## STAFF REPORT

**TO:** CITY COUNCIL  
**AGENDA ITEM:** Inwood 7<sup>th</sup> Addition – Amended and Restated Resolution Approving the Final Plat – Resolution 2023-070  
**FROM:** Sarah Sonsalla, City Attorney  
**REVIEWED BY:** Jack Griffin, City Engineer  
Kristina Handt, City Administrator  
Sophia Jensen, City Planner

**RESOLUTION 2023-070**

**AN AMENDED AND RESTATED RESOLUTION APPROVING THE FINAL PLAT OF  
INWOOD 7th ADDITION**

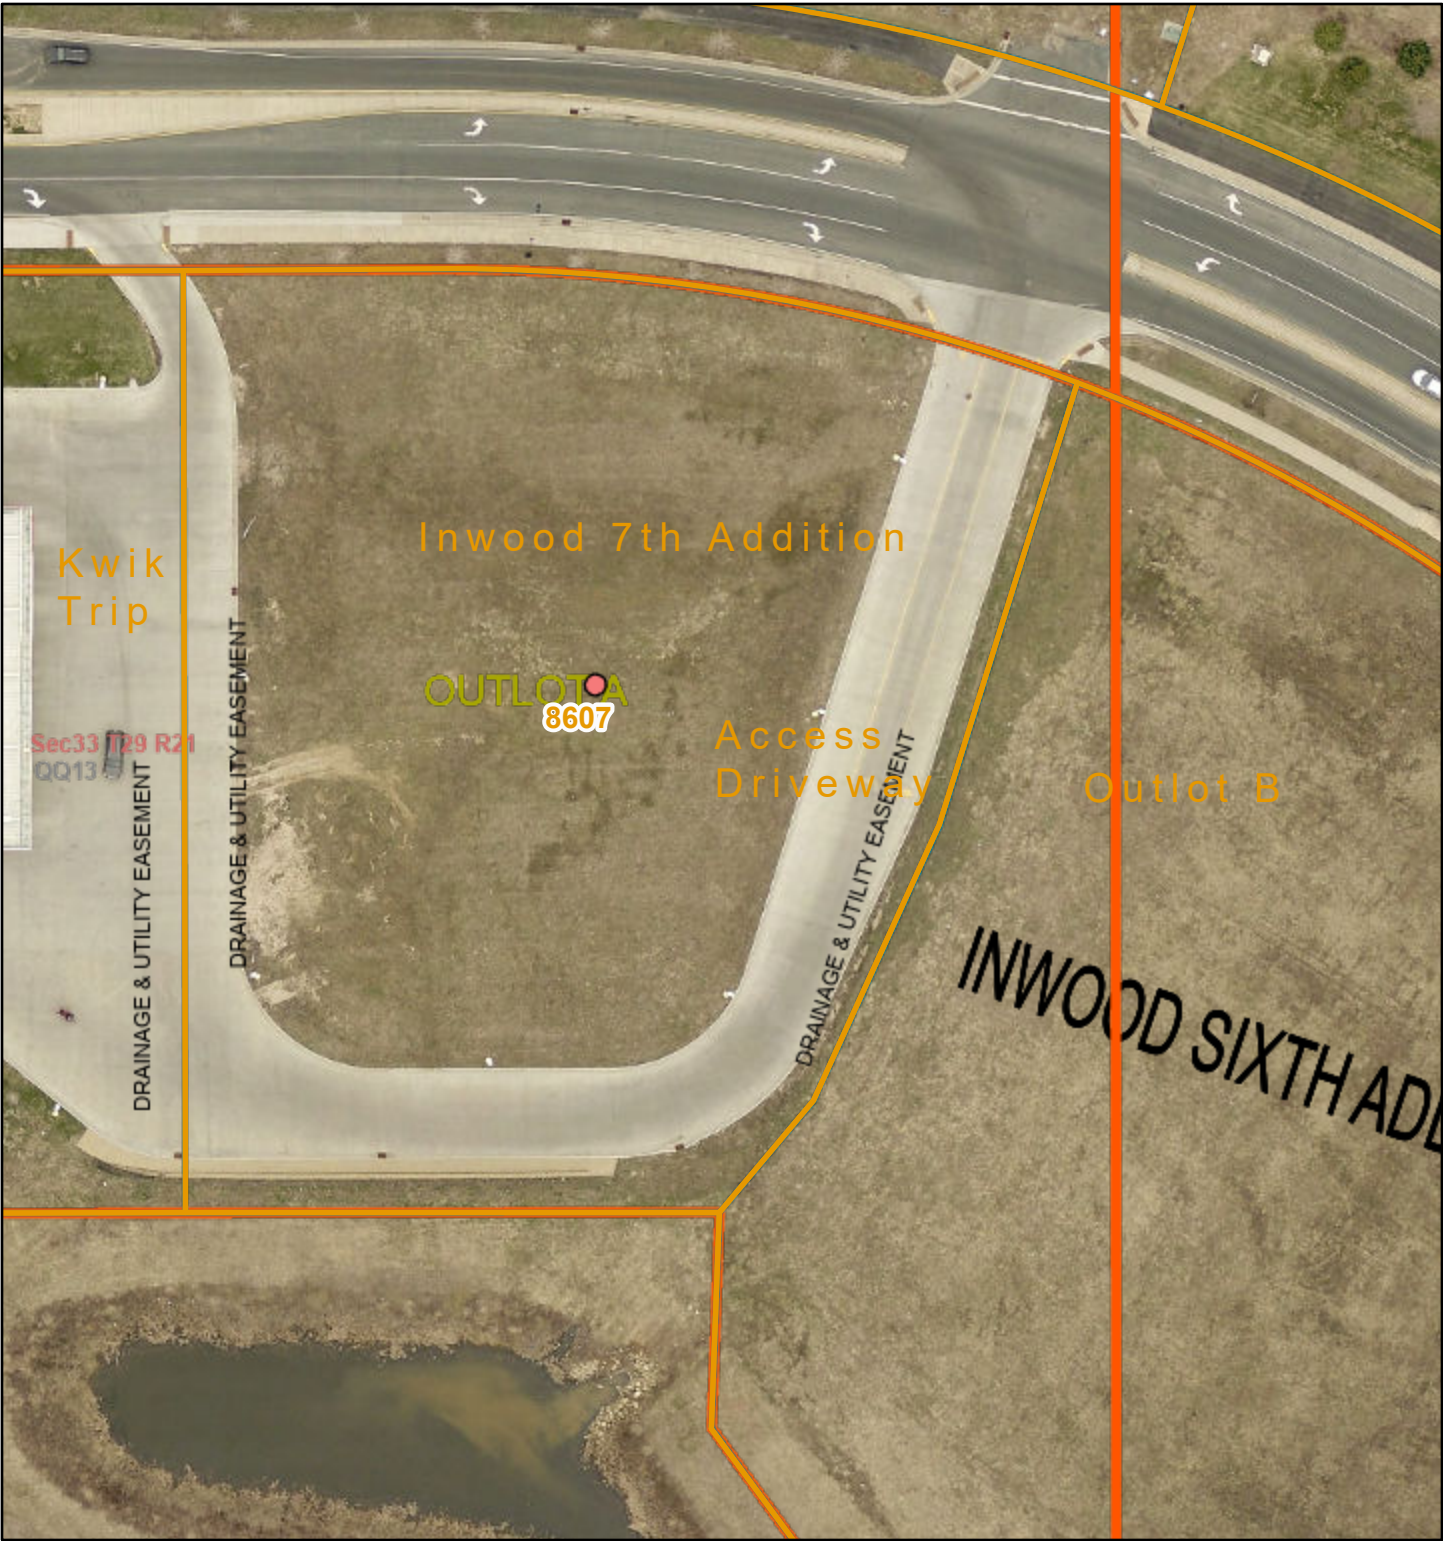
Approval of the final plat by the City Council was subject to a number of conditions which are outlined in Resolution 2022-114. Condition Number 8 of the Resolution states that “Outlot B of Inwood Sixth Addition shall be granted full access to the existing commercial driveway off of 5<sup>th</sup> Street North.”

The Applicant’s attorney reached out to me to seek clarification of this condition. Outlot B of Inwood Sixth Addition is located adjacent to the Inwood 7<sup>th</sup> Addition property on the eastern side. Kwik Trip is located adjacent to the Inwood 7<sup>th</sup> Addition property on the western side. The Applicant’s attorney wanted to know if City was requiring an access easement to benefit Outlot B over just the Inwood 7<sup>th</sup> property or also over the Kwik Trip property (because the access drive wraps around Inwood 7<sup>th</sup> Addition and goes over the Kwik Trip property). It was confirmed with the City Engineer that the intent of this condition was to ensure that Outlot B has access over the Inwood 7<sup>th</sup> Addition property to 5<sup>th</sup> Street North so that another access to 5<sup>th</sup> Street will not be needed for Outlot B when Outlot B is developed. Therefore, an access easement in favor of Outlot B over the Kwik Trip property is not required or necessary.

Should Condition Number 8 of Resolution No. 2022-114 be changed to clarify the scope of the access easement that is being required by the City?

“Outlot B of Inwood Sixth Addition shall be granted an access easement so that Outlot B may utilize the existing driveway located on the eastern portion of Inwood 7<sup>th</sup> Addition to access 5<sup>th</sup> Street North.”

8. That Outlot B of Inwood 6th Addition shall be granted an access easement so that Outlot B may utilize the existing driveway located on the eastern portion of Inwood 7th Addition to access 5th Street North.
